Product Change Notice (PCN)

Subject: Change Shipping Media on Select Package

Renesas is converting shipping media from Tube to Tray on package TSOP-44. The current shipping media in Reel remains unchanged.

Appendix B - Shipping Tray Comparison

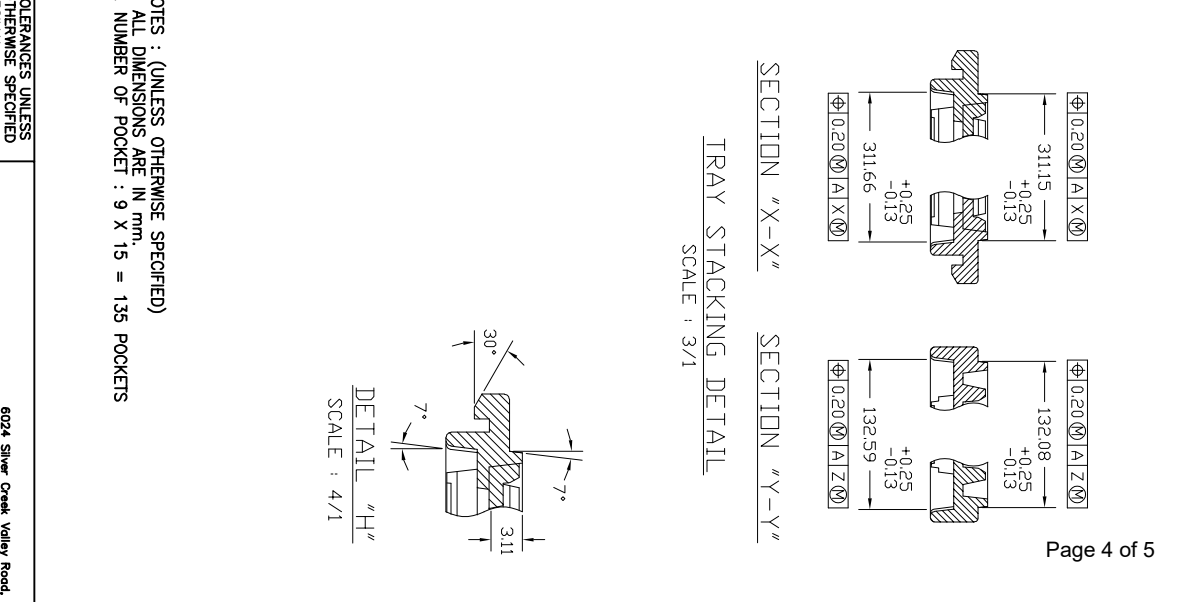
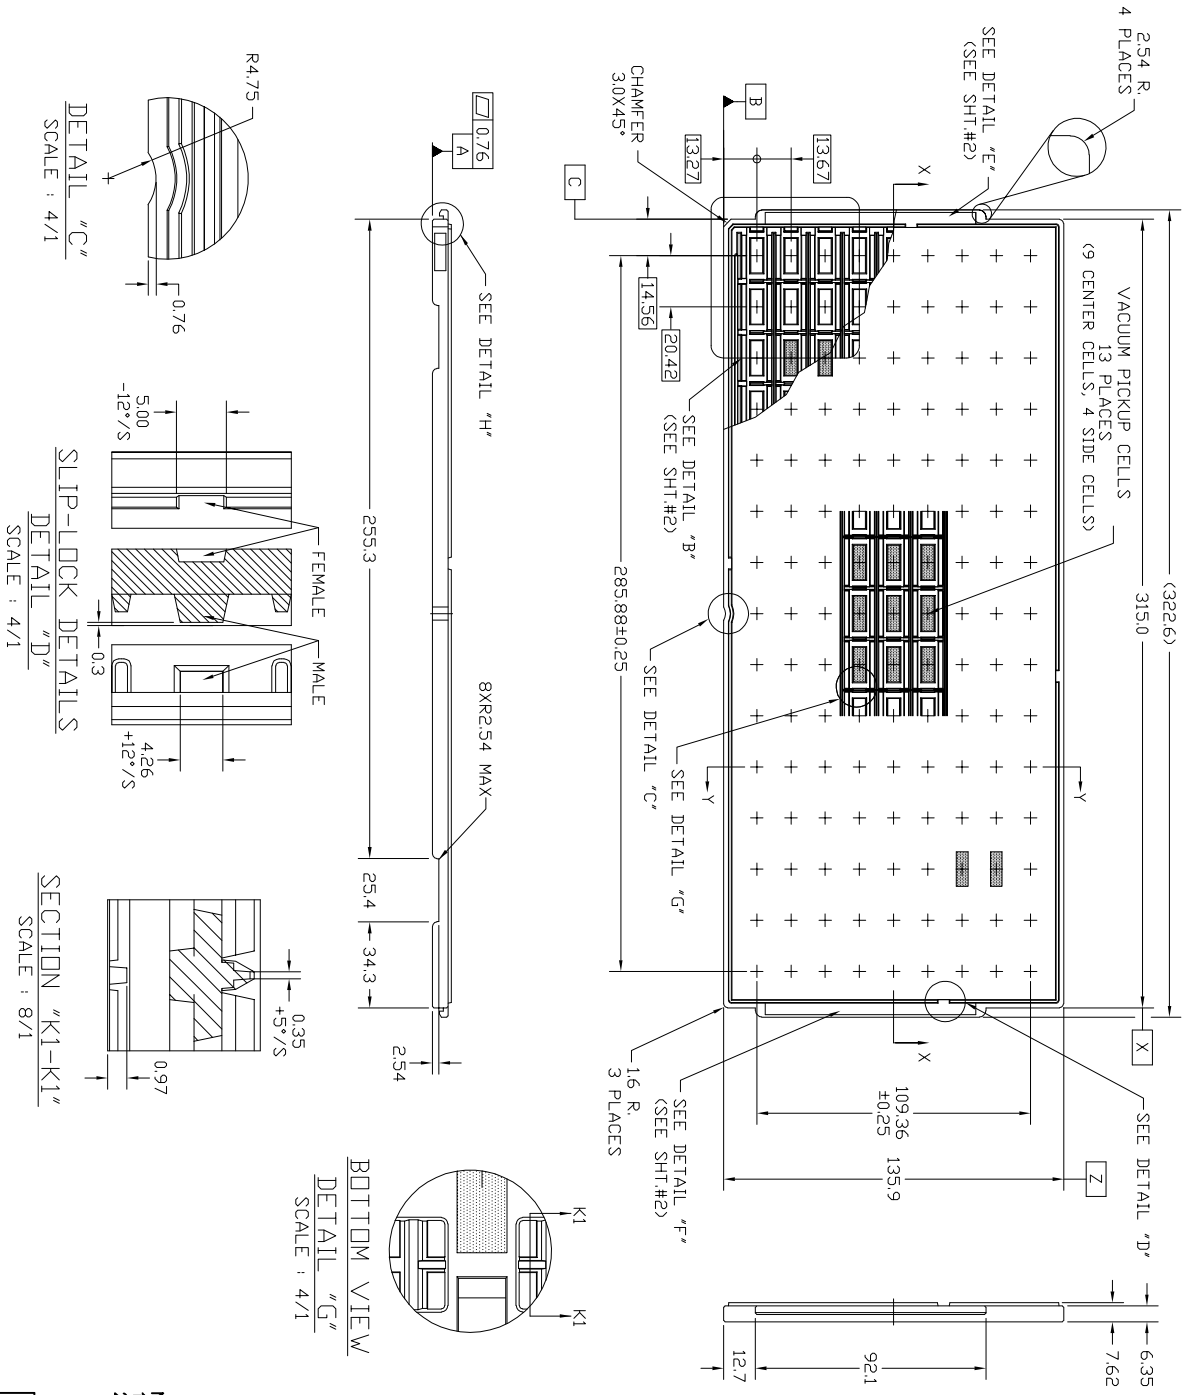
An Industrial standard JEDEC shipping tray will be introduced. In addition, one of the Orderable Part# that is presently ship in Tray (Tray part# 124-4725-119) will convert to the new Tray (New Tray part# TR142050). The MOQ and FOI in Tray shipment shall change to 135 units. Refer Appendix A and Appendix B for more information.

Descriptions	Current (Shipping Tray, part# 124-4725-119)	New (Shipping Tray, part# TR142050)
Supplier	DAEWON	DAEWON
Tray Material	MPPO	MPPO
Tray Matrix	8x12	9x15
Units Per Tray	96	135
Row Pitch	15.16 mm	13.67 mm
Colum Pitch	25.50 mm	20.42 mm
